On-Property Corrective Measures Implementation Construction Completion Report

Subject:
On-Property CMI Construction Documentation Report
Koppers Inc. Superior, Wisconsin Facility
WDNR BRRTs No: 0216000484
WDNR Facility ID: 816009810

**On-Property Corrective Measures
Implementation Construction
Documentation Report**

Koppers Inc. Facility
Superior, Wisconsin

STATION 3+85

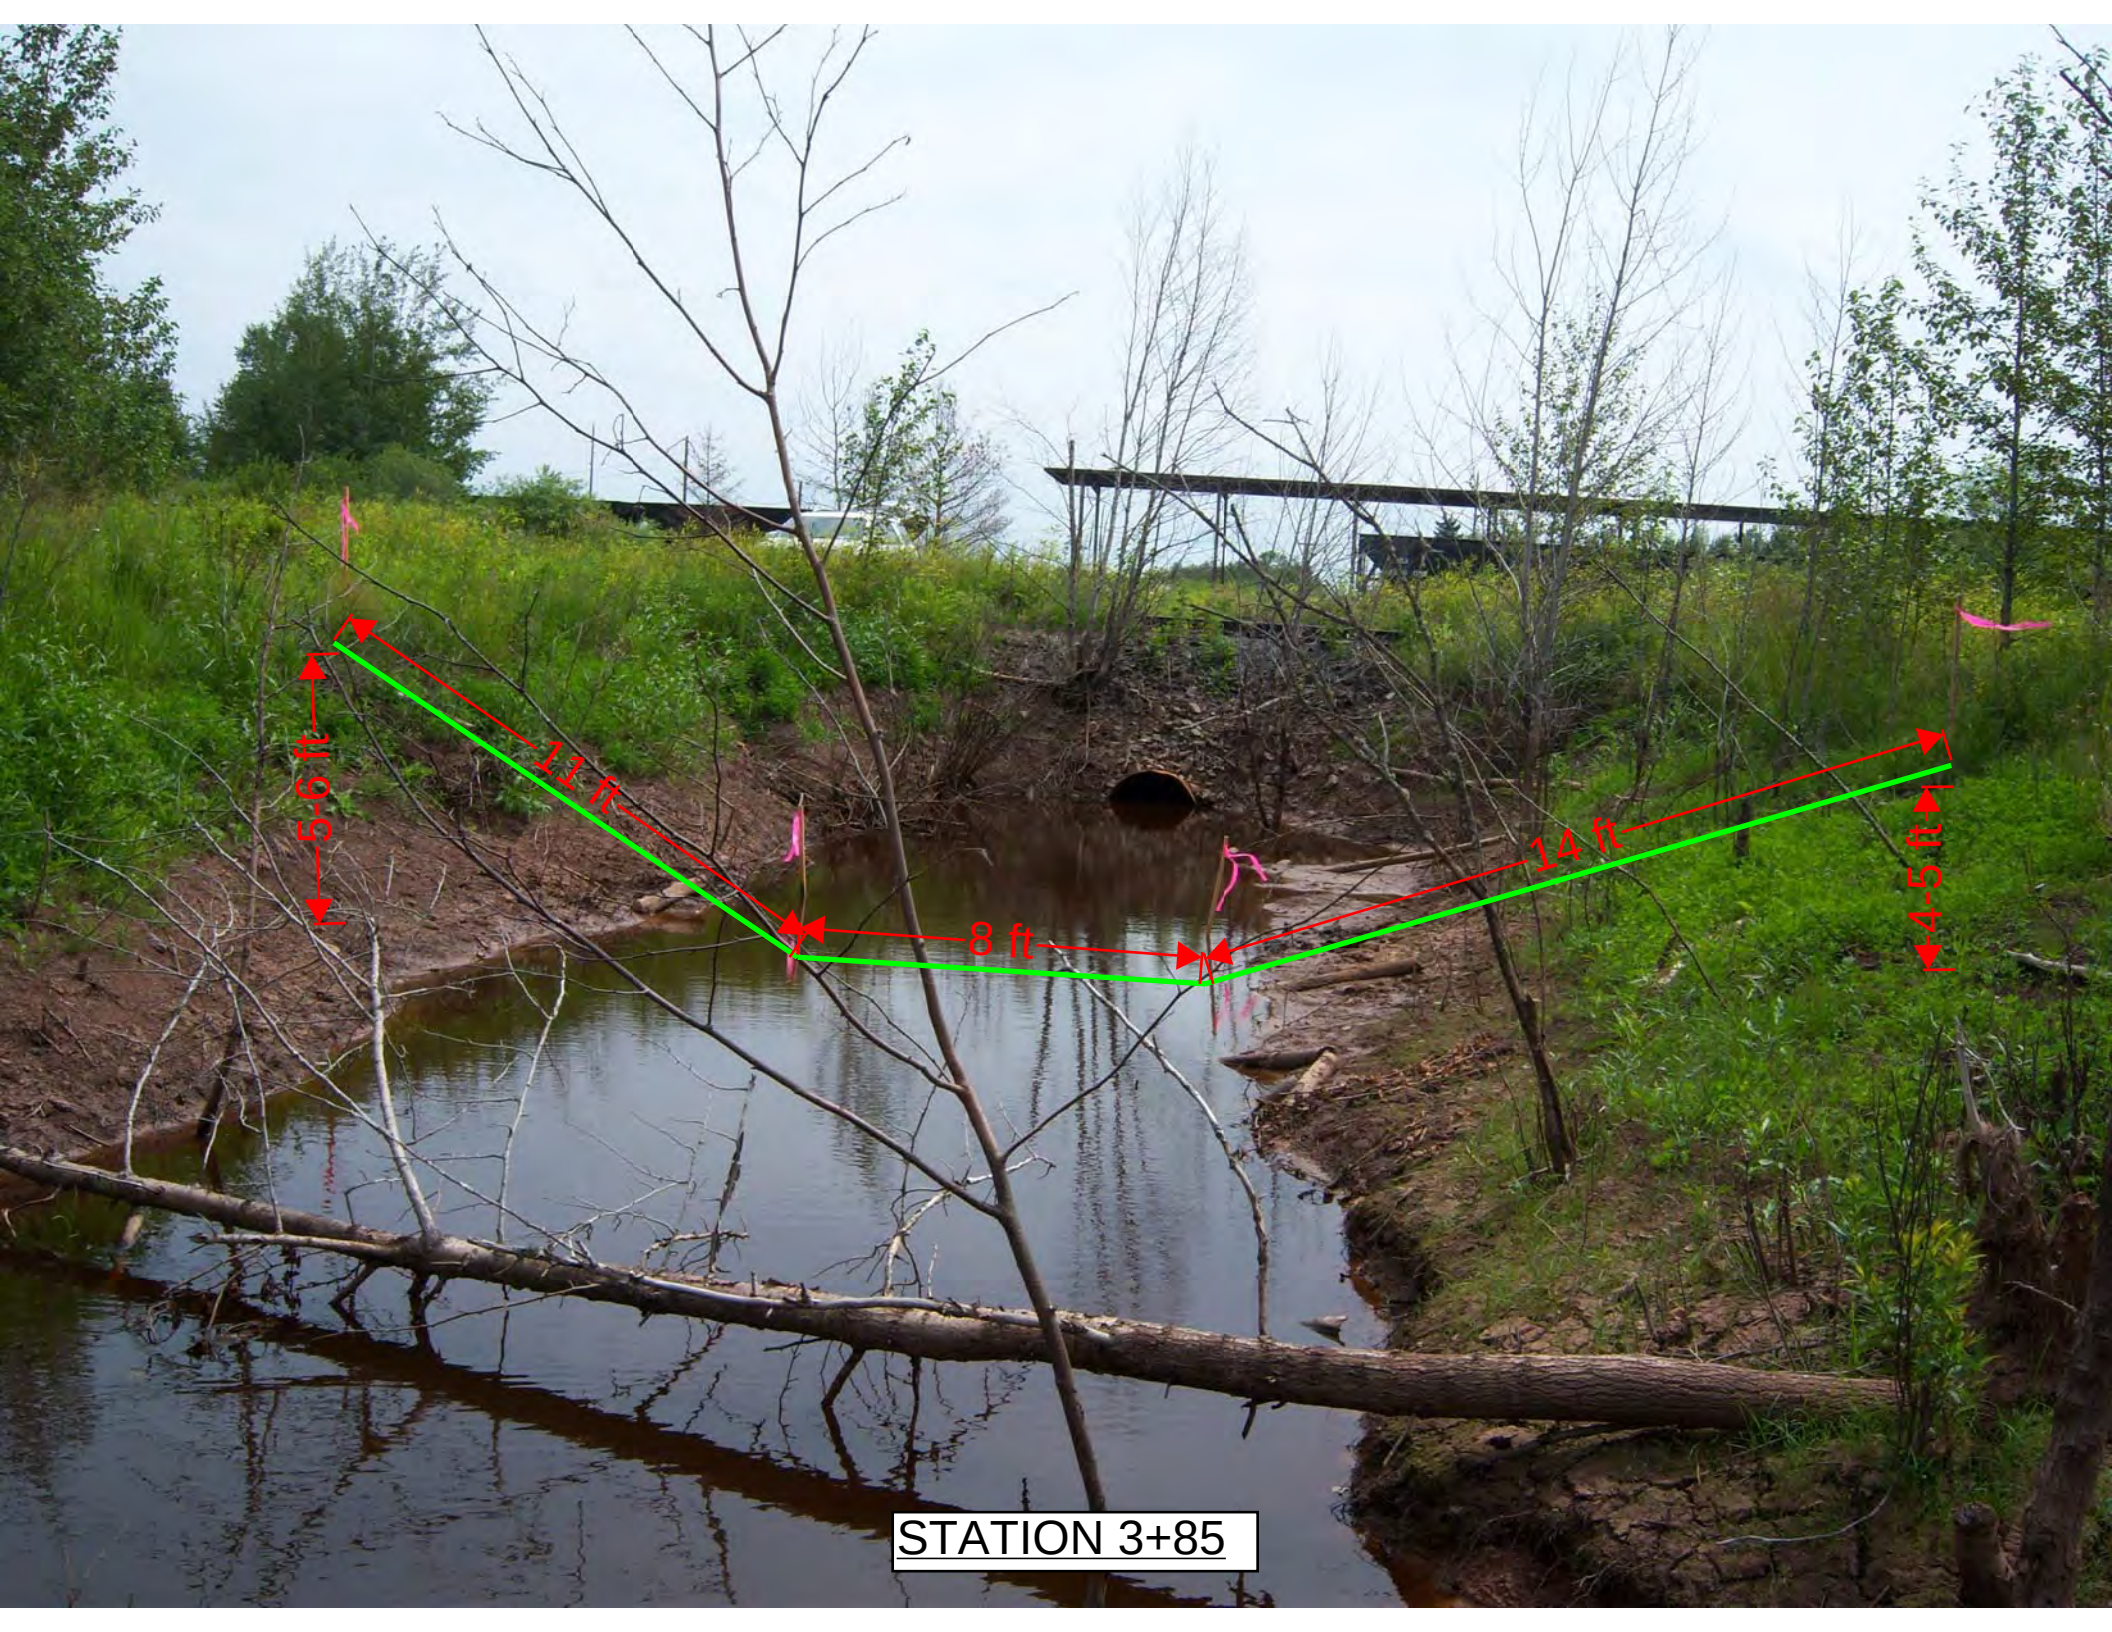
As discussed during the June 11, 2010 meeting at Severson's office in Delmont, Pennsylvania, due to high water in the Outfall 001 drainage ditch during the pre-design survey, the surveyor was unable to record the existing channel geometry. The typical on-property channel cross-sections depicted on Contract Drawing C301, which represent the minimum restored channel dimensions required to maintain proper Facility drainage, were used by Severson to determine the necessary quantities of the Outfall 001 drainage ditch restoration materials for their "Gray Book" Project Cost Estimate (Gray Book). Because the channel should not be filled with additional materials to achieve the minimum dimensions shown on Contract Drawing C301, the quantities of Outfall 001 drainage ditch restoration materials included in the Gray Book are potentially less than the actual required restoration material quantities. As an alternative to hiring a surveyor to conduct an additional survey of the Outfall 001 drainage ditch during lower-water conditions so that the restoration material quantities could be verified, Beazer decided to increase the Outfall 001 drainage ditch restoration material quantities by 30%.

During a July 13, 2010 site visit by ARCADIS, it was noted that the Outfall 001 drainage ditch water levels were low and the actual existing channel geometry at three locations was recorded. Photographs of these three transects and the existing channel dimensions are included as Attachment 1. As shown in Attachment 1, the existing channel dimensions, and therefore the restored channel dimensions, are increased from than the typical on-property channel cross-sections depicted on Contract Drawing C301.

ARCADIS calculated the quantities of all Outfall 001 drainage ditch restoration materials. The following table compares the quantities included on Contract Drawing C100 and the "Estimate Worksheet – Outfall Drainage Ditch Restoration" of the Gray Book with the estimated required quantities based on the existing channel geometry measured on July 13, 2010:

Material	C100 Quantity	"Gray Book" Quantity	Revised Quantity
Pea Gravel	--	390 ton	306 cy ^{1,2}
Reactive Core Mat	--	1,850 square yards (sy)	2,377 sy ³
General Fill	--	240 cy	344 cy
Non-Woven Geotextile	--	20,800 square feet (sf)	28,405 sf ³
R3 Riprap	900 cy	1,170 ton	915 cy ²

TYPICAL CLAY VEGETATED SURFACE COVER

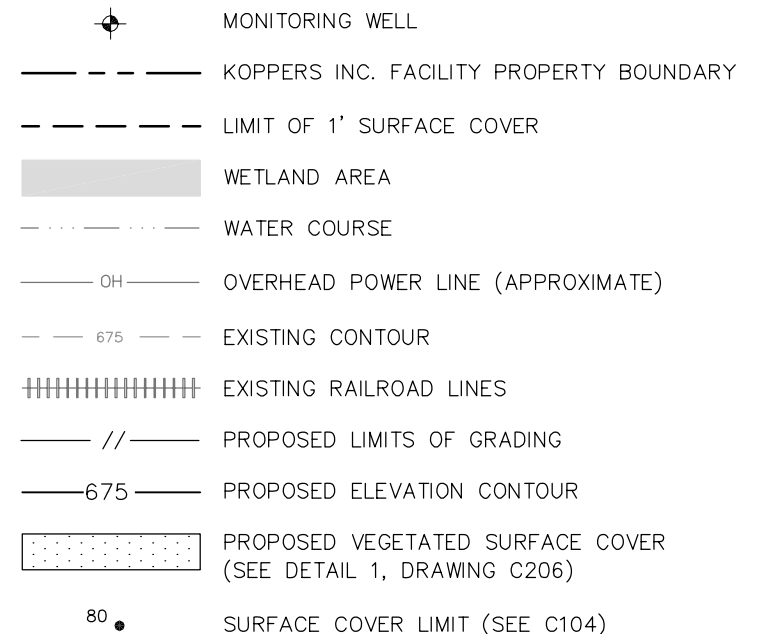
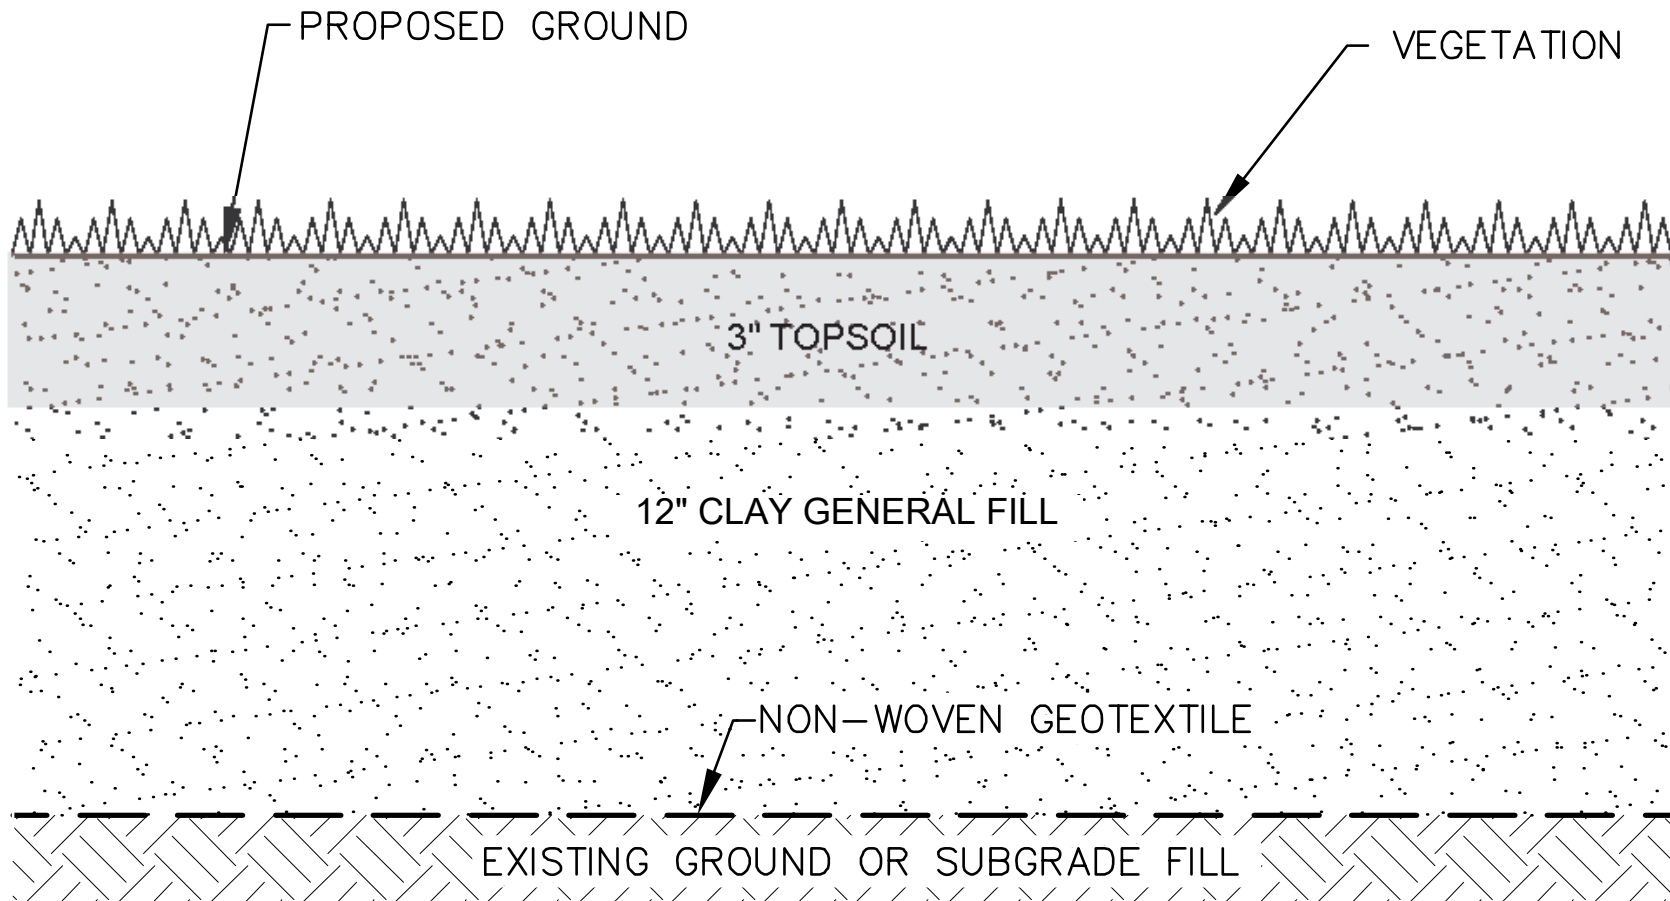
- b. Surface Cover Construction – Install **Clay** Vegetated Surface Cover, in accordance with the **revised** Contract Drawings and the **revised** Quality Control Requirements listed in Table 1 (**Attachment 1 of this Field Order**).

- b. Surface Cover Construction – Place geotextile over the prepared subgrade surface and install **Clay** Vegetated Surface Cover and Road Base Surface Cover in accordance with the **revised** Contract Drawings (**Attachment 1 of this Field Order**). Compact fill materials in accordance with Table 1 (**Attachment 1 of this Field Order**).

PROPOSED CLAY VEGETATED SURFACE COVER (SEE FIGURE 1) - MATCH EXISTING GRADES
(INSTALL WITHIN EXISTING WETLAND LIMITS, SEE "WETLAND BOUNDARIES", DRAWING C102)

FINAL GRADING PLAN - AREA G

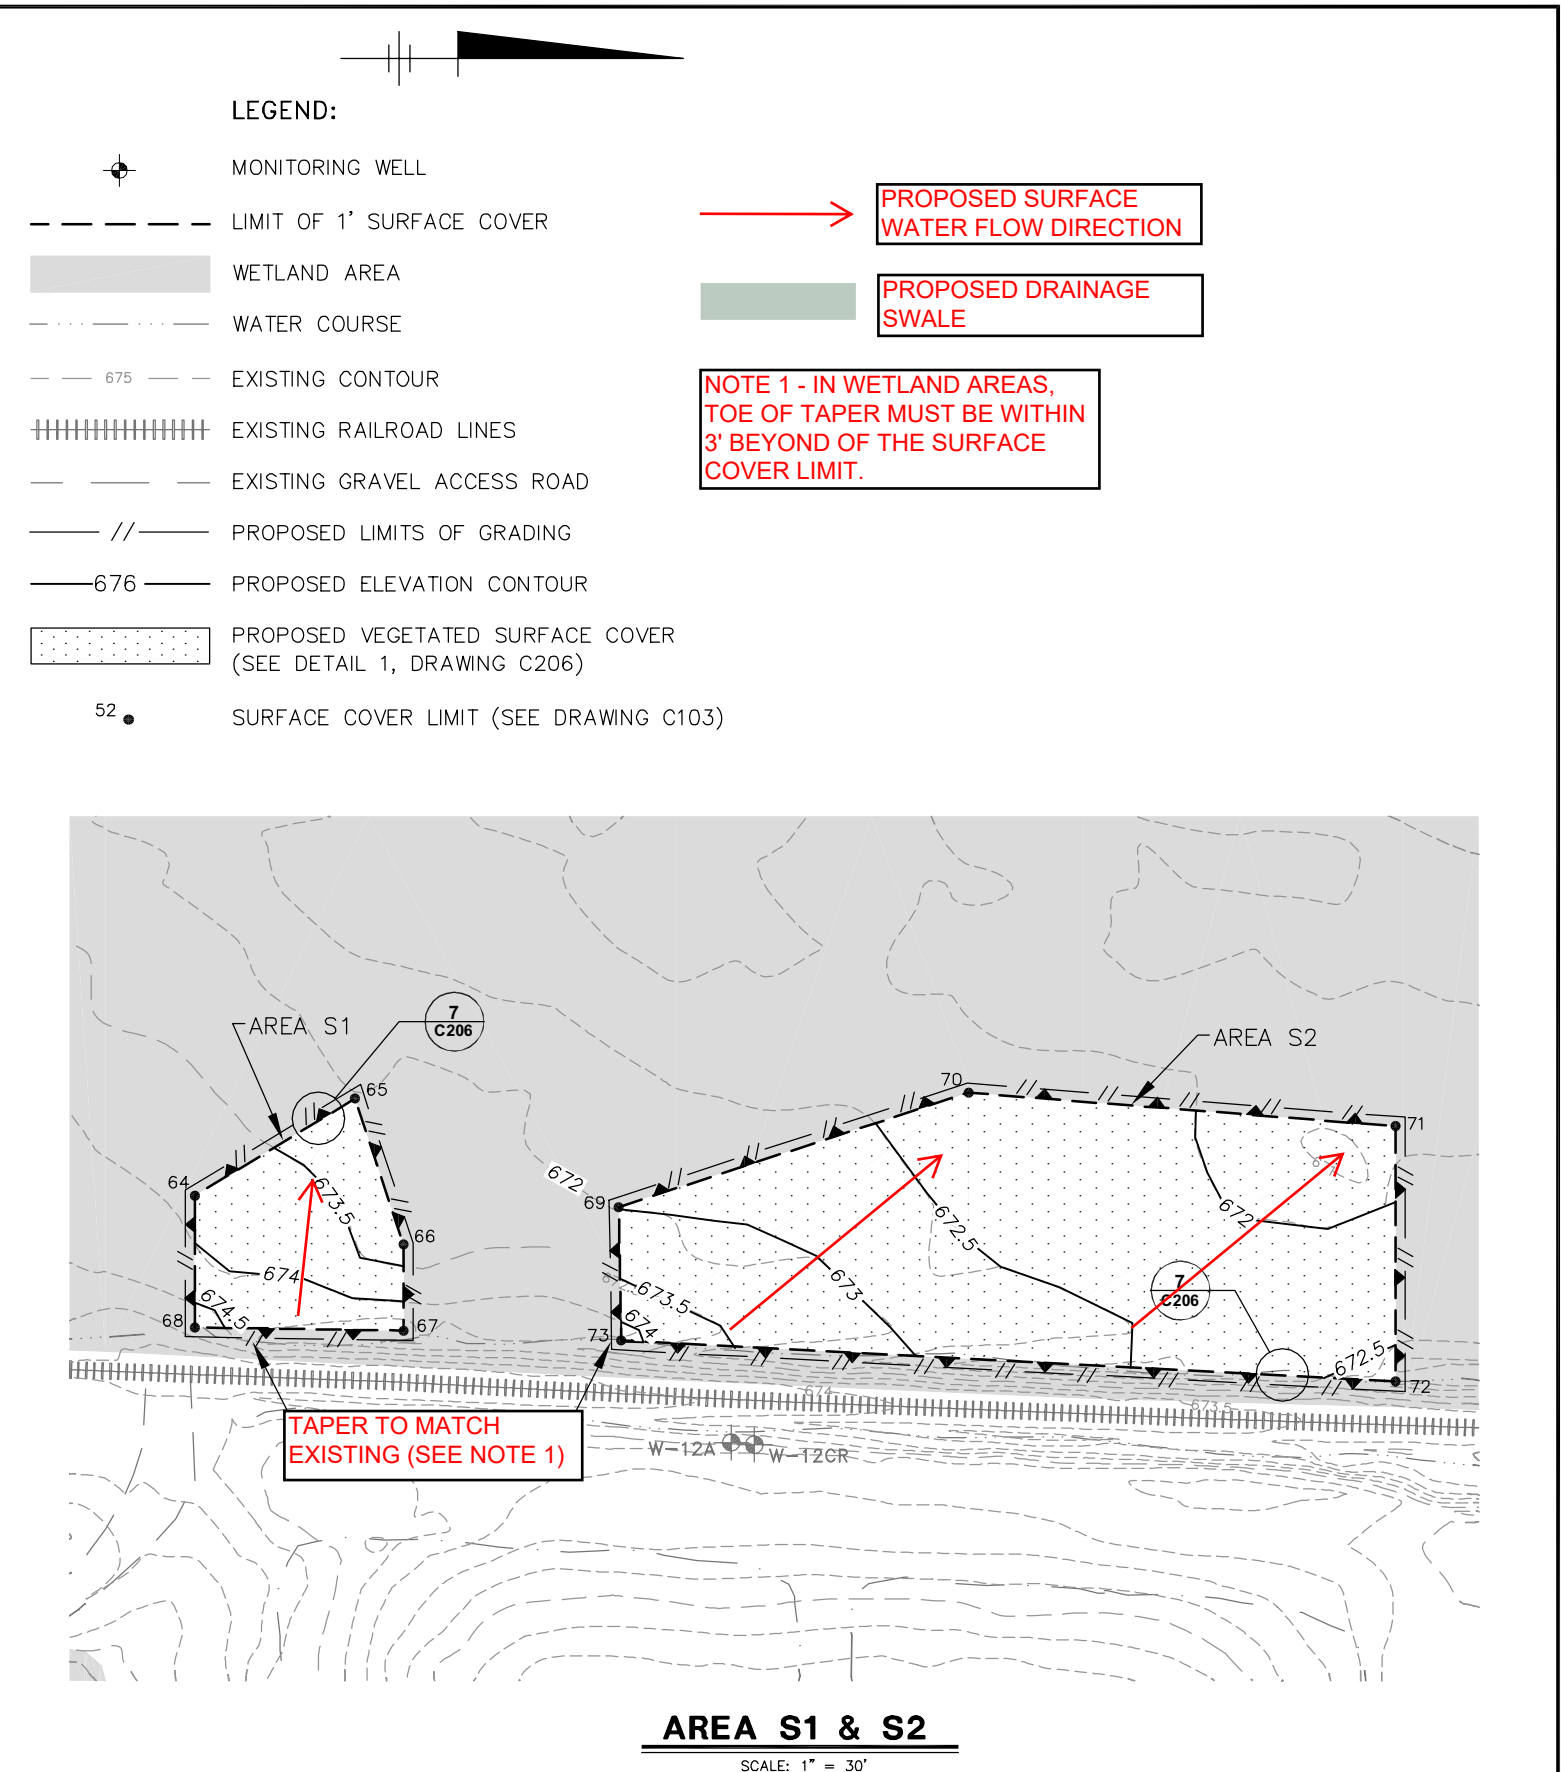
Standing water and very soft conditions have been encountered at Areas G, H, S1 and S2 (see Photographs 1 and 2 below). Woven geotextile and angular stone will be placed in these wet areas, as necessary, to bridge the standing water and soft soils and provide a stable surface for installation of the Clay Vegetated Surface Covers.

- a. Subgrade Leveling – ~~Proof roll the surface cover area with a smooth drum or sheepsfoot roller to identify soft areas and provide a level of compaction for the existing grade. If soft areas are identified, treat the soft spots with cement or LKD.~~ Place ~~non~~-woven geotextile over the prepared subgrade. Place angular stone over the woven geotextile, as necessary, to “bridge” the standing water and soft soils.

- b. Surface Cover Construction – Install **Clay** Vegetated Surface Cover, in accordance with the **revised** Contract Drawings (**Attachment 1 of this Field Order**) and the **revised** Quality Control Requirements listed in Table 1 (**Attachment 1 of Field Order 2**). The final surface of the Clay Vegetated Surface Cover should provide drainage away from the existing railroad tracks. At the edges of the Clay Vegetated Surface Covers adjacent to wetlands, the toe of the taper to match existing grades must be sloped to not extend over 3 feet beyond the surface cover limit.
